AMENDMENTS TO THE DRAWINGS

REMARKS

Title: Redistribution Layer Shielding of a Circuit Element

App. No. 10/814,816

FIG. 5B

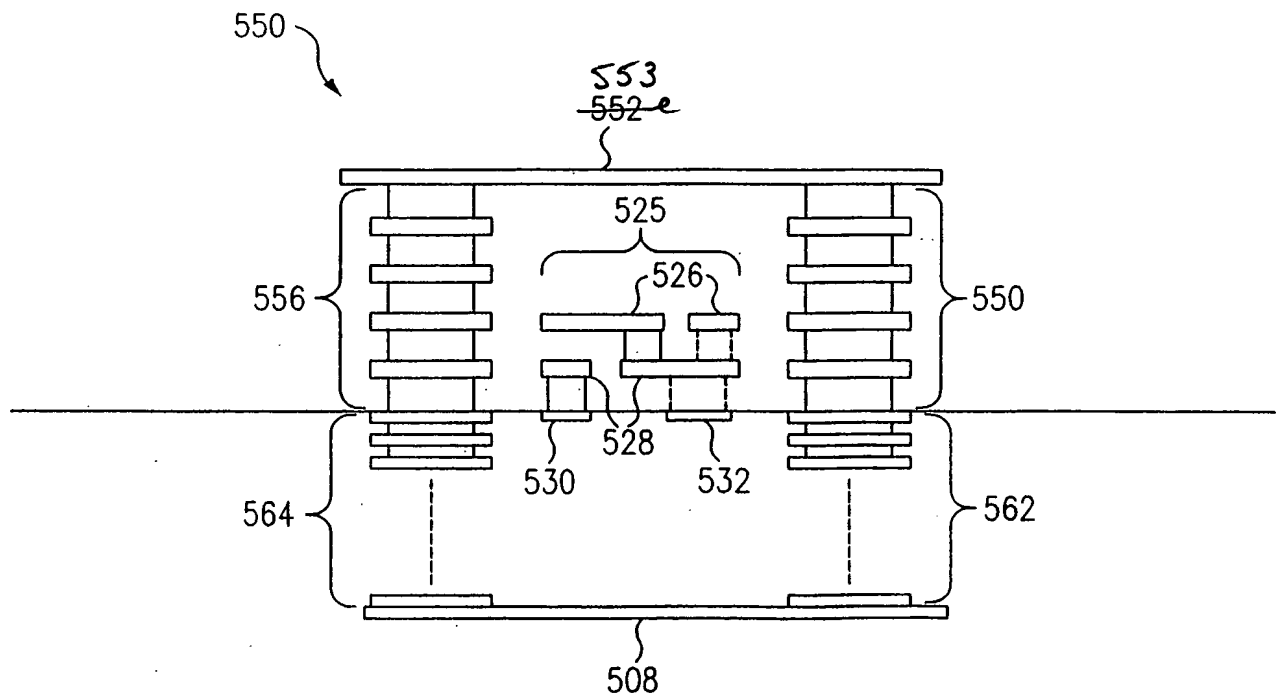
Figure 5B is amended to change the reference numeral of top plate 552 to top plate 553.

The specification is amended to be consistent with the drawings. The specification is amended to change the reference numeral of top plate 552 of FIG. 5B to top plate 553.

FIG. 9A

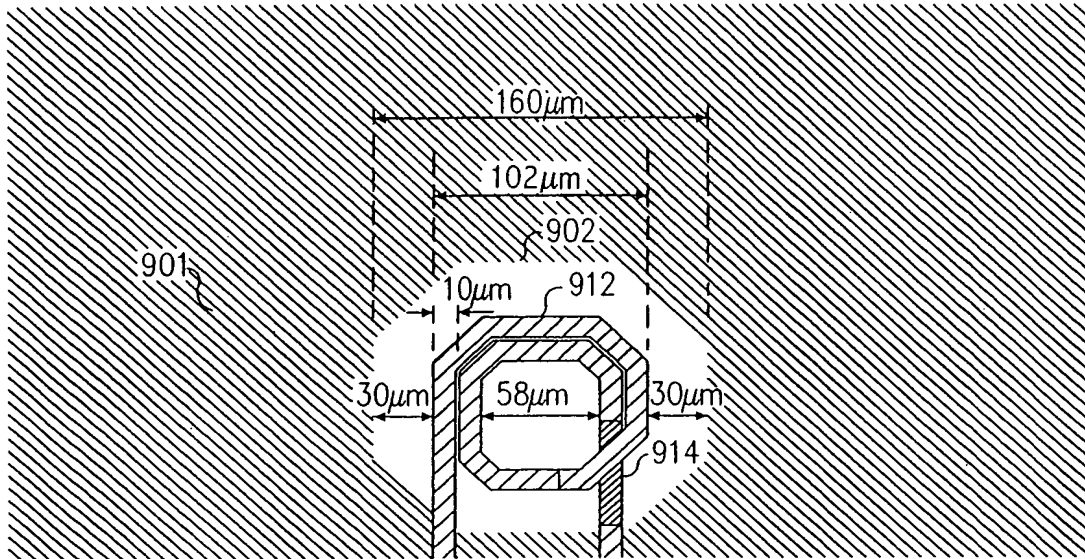
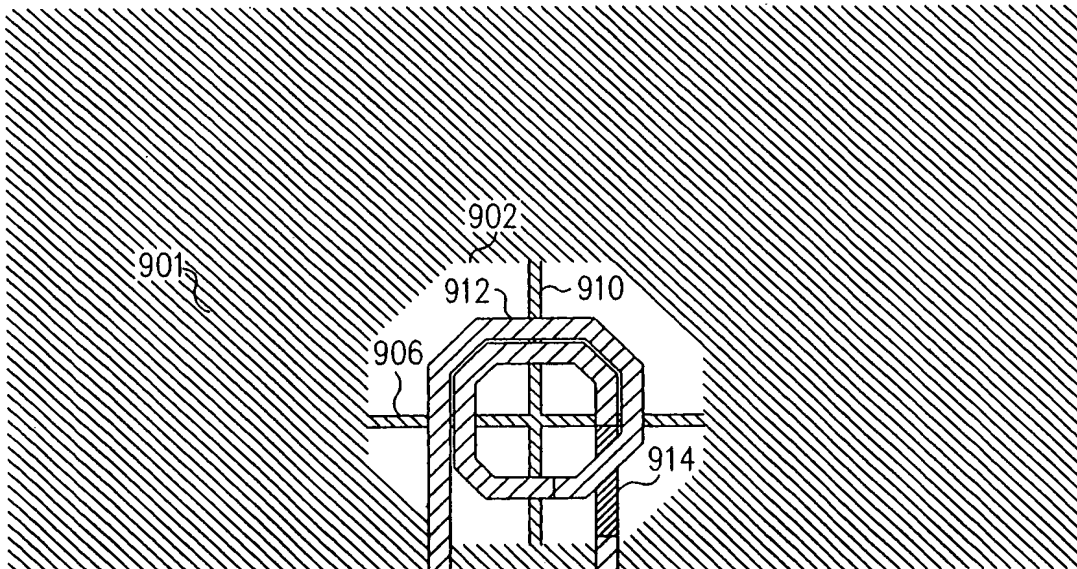
The drawings are objected to as failing to comply with 37 C.F.R. 1.84(p)(5) because they include the following reference characters not mentioned in the description: 1000, 1002, 1004, 1006, 1008, 1010, 1016, and 1066. Figures 9A, 9B, 9C and 10 are amended consistent with the specification.
